re: Geotechnical Design Summary Details
Proposed Residential Development
Riverside South Phase 15-1B – Block 196 – 910 Solarium Avenue, Ottawa

file: PG5131-MEMO.05

Grading Plan Review

Drawing Title
GRADING PLAN

Design	L.E.	Date	2022-07-20
Drawn	C.C.	Checked	L.E.
Project No.	103291	Drawing No.	204

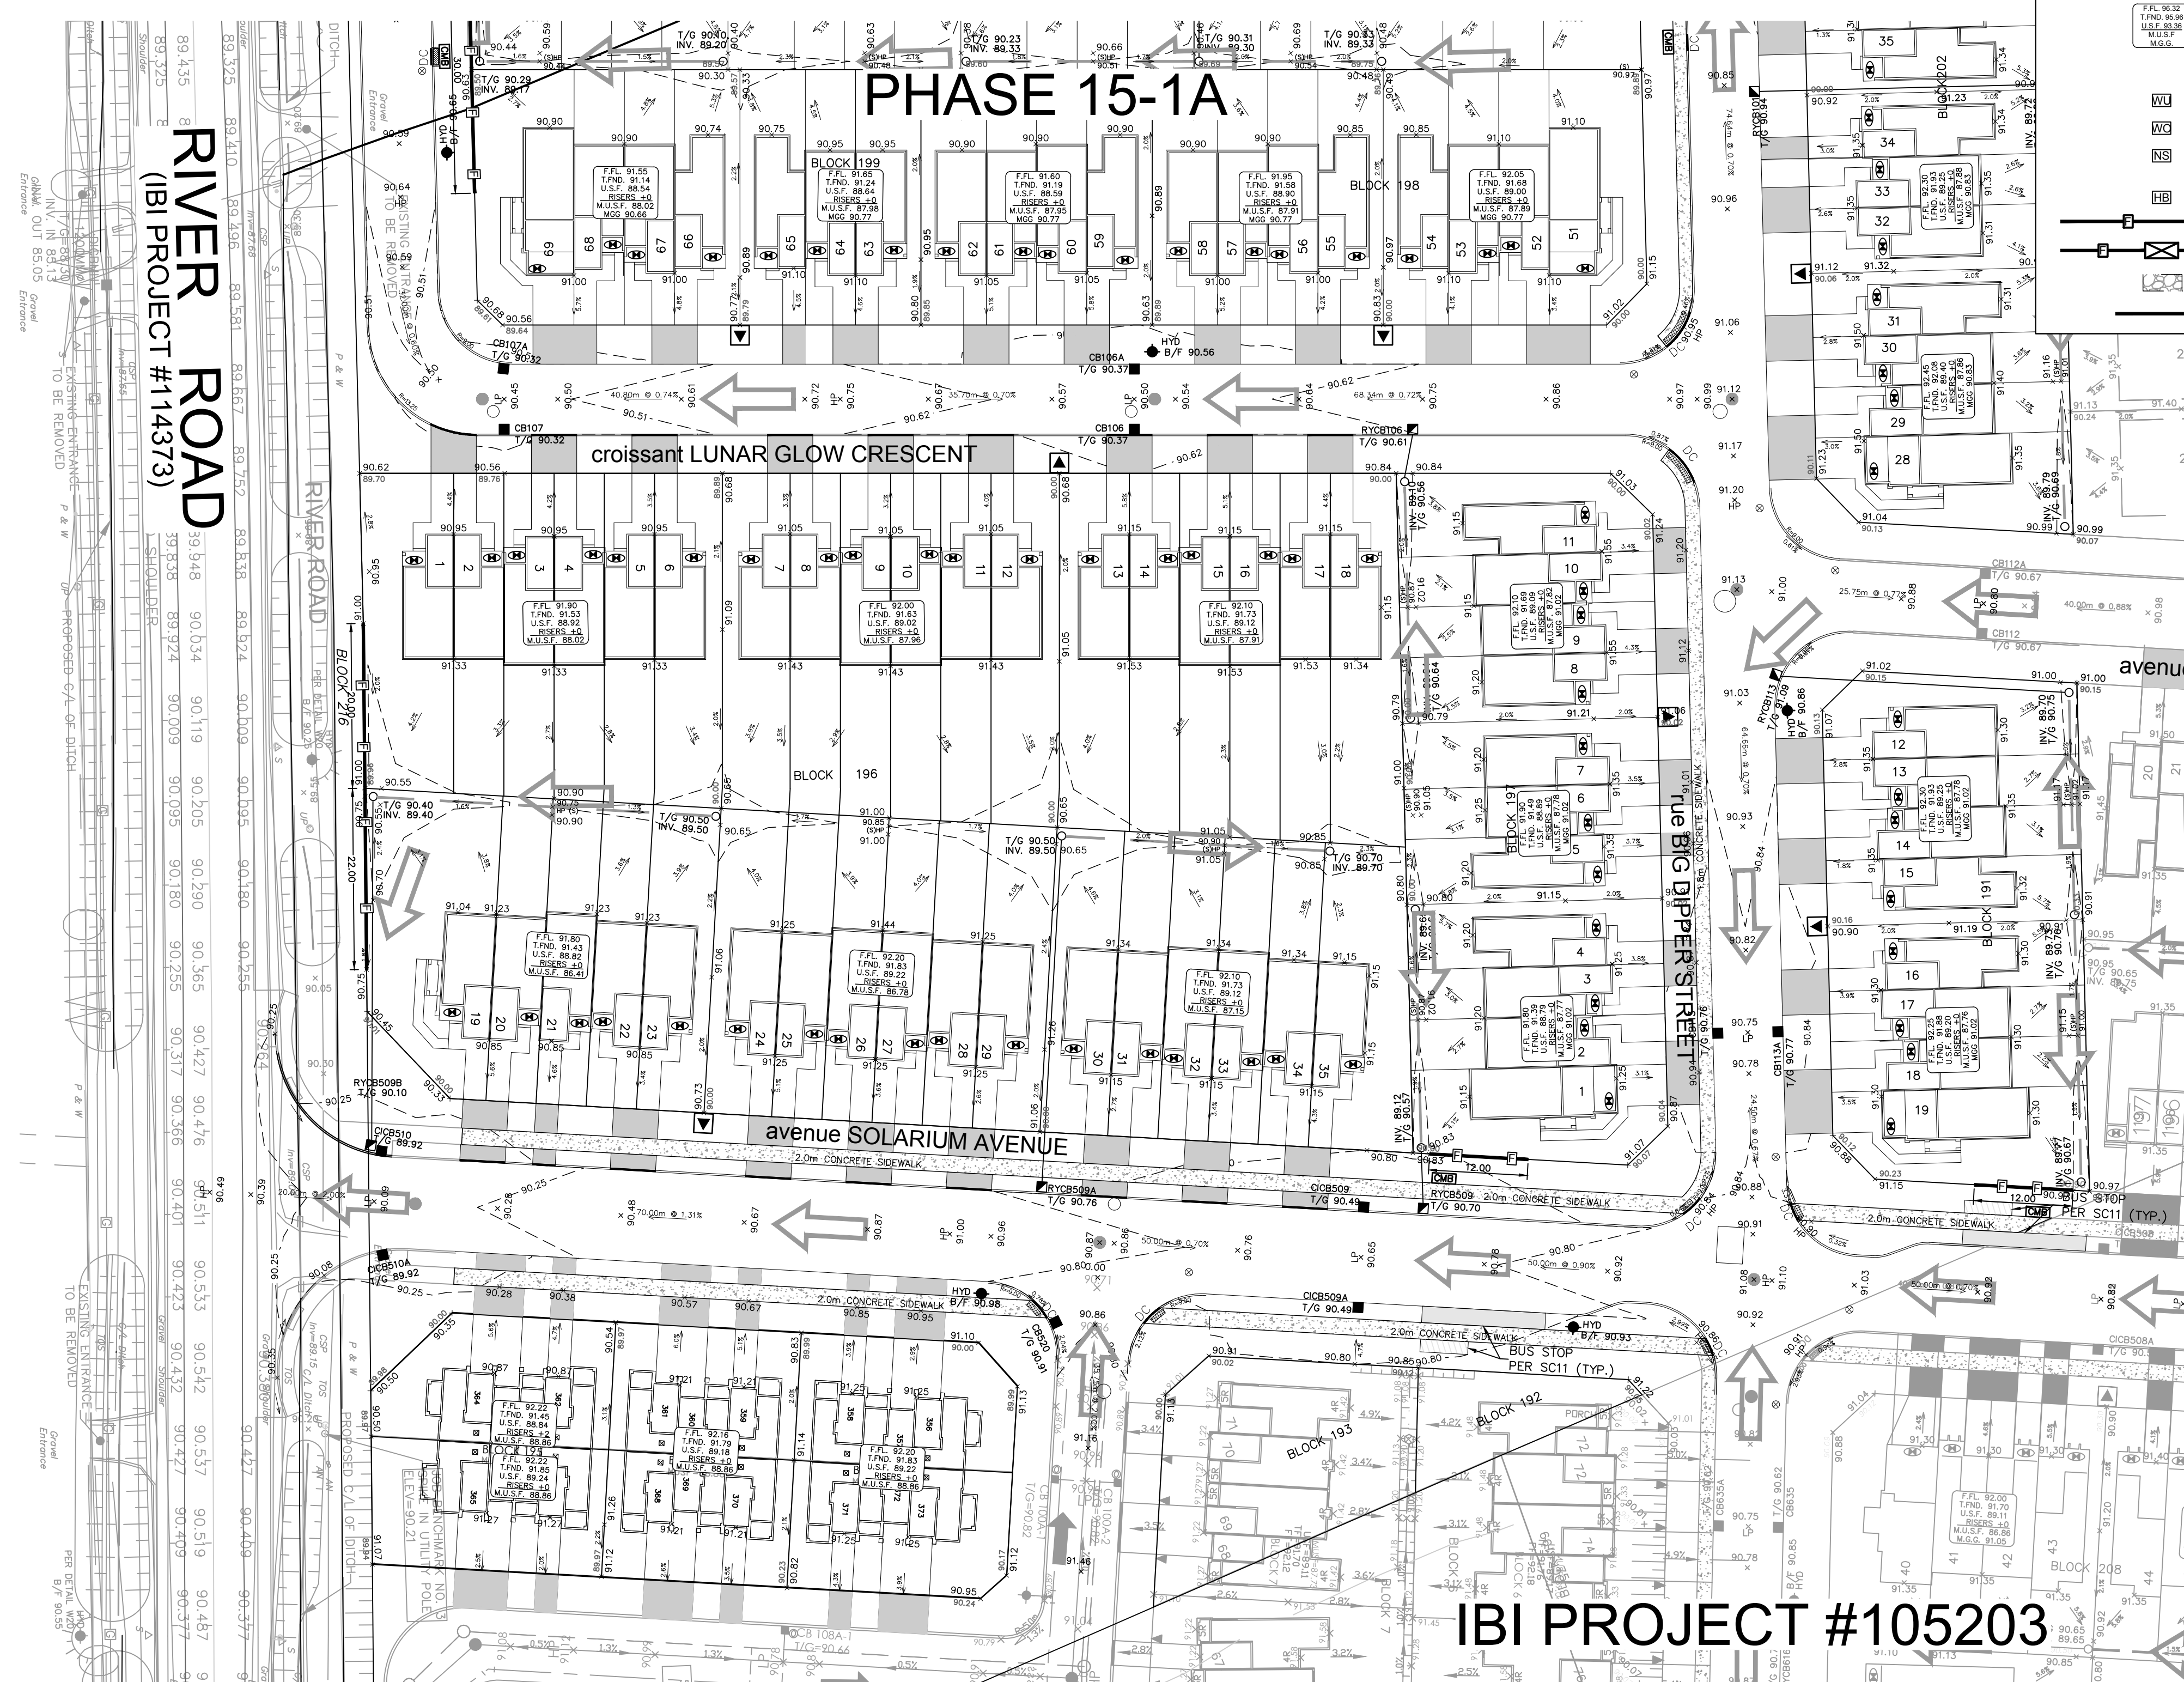
Based on our review of the aforementioned grading plan, the proposed grades are within the permissible grade raise restriction of **2.1 m** provided throughout the subject phase/block of the proposed development and in the aforementioned geotechnical report. Therefore, the proposed grading is considered acceptable from a geotechnical perspective and no lightweight fill or other considerations to accommodate the proposed grades are required at this time. Table 1 attached to this memorandum provides a grading summary of the subject buildings based on our grading plan review.
